Item 5.**Development Application: 56A Allen Street, Glebe - D/2023/790**

File No.: D/2023/790

Summary Recommendation: This proposal is recommended for refusal.

Figure 18: Proposed west (Allen Street) elevation

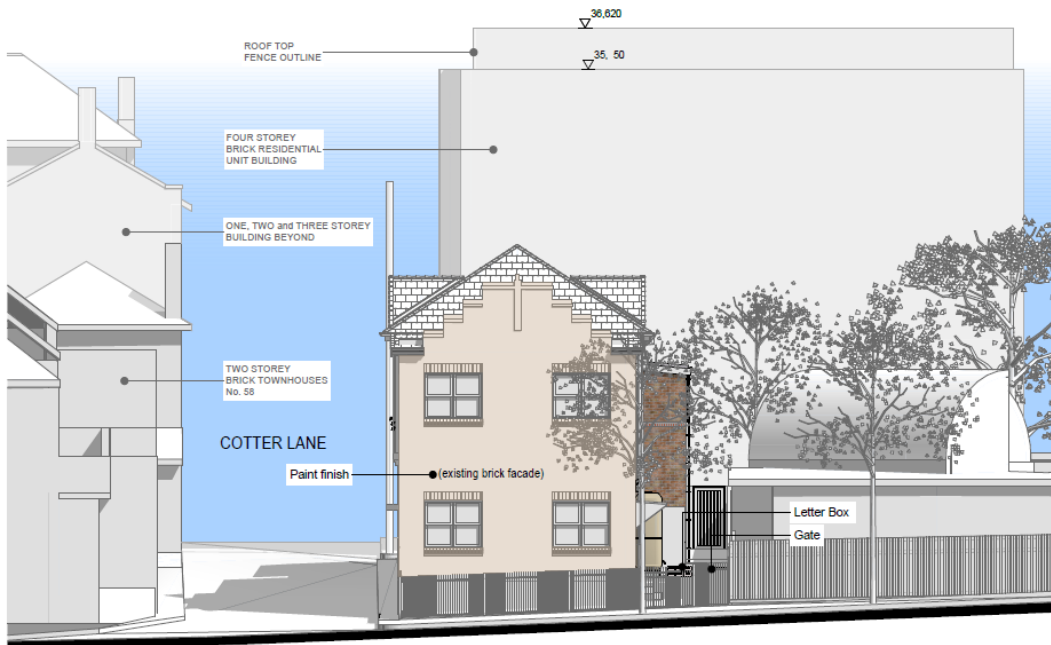
32. The applicant has not adequately addressed objective (a) to ensure the height of development is appropriate to the site and its context. The applicant is correct in asserting there are buildings surrounding the dwelling that are of greater height than the proposed development. This is due to varying height controls as well as dwellings that exceed the 6 metre height limit along Allen Street. However, it is not agreed that the development is appropriate to the site, as the addition is not sympathetic to the existing building and poorly articulated when viewed from Allen Lane.

33. The applicant has not demonstrated that there are sufficient environmental planning grounds to justify contravening the standard.
34. The applicant states that the noncompliance relates to the roof form, which matches the angle and slope of the existing rear skillion form of the existing higher building on the site to the immediate west and that it is an appropriate approach for the addition, on a visible corner site, in a Conservation Area. Council officers consider the skillion roof form to be too prominent, as it does not relate sympathetically to the site and appears poorly articulated when viewed from Allen Lane.

Figure 21: Proposed south elevation

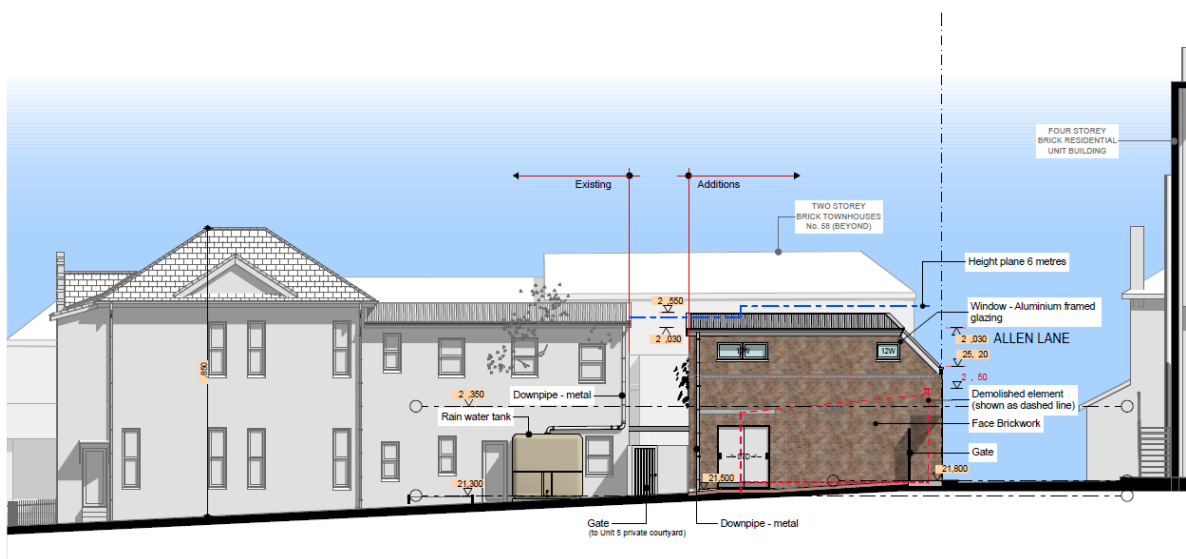
Response: The proposed first floor windows on the southern façade contain a sill height of 1.6 metres, an acceptable privacy measure.
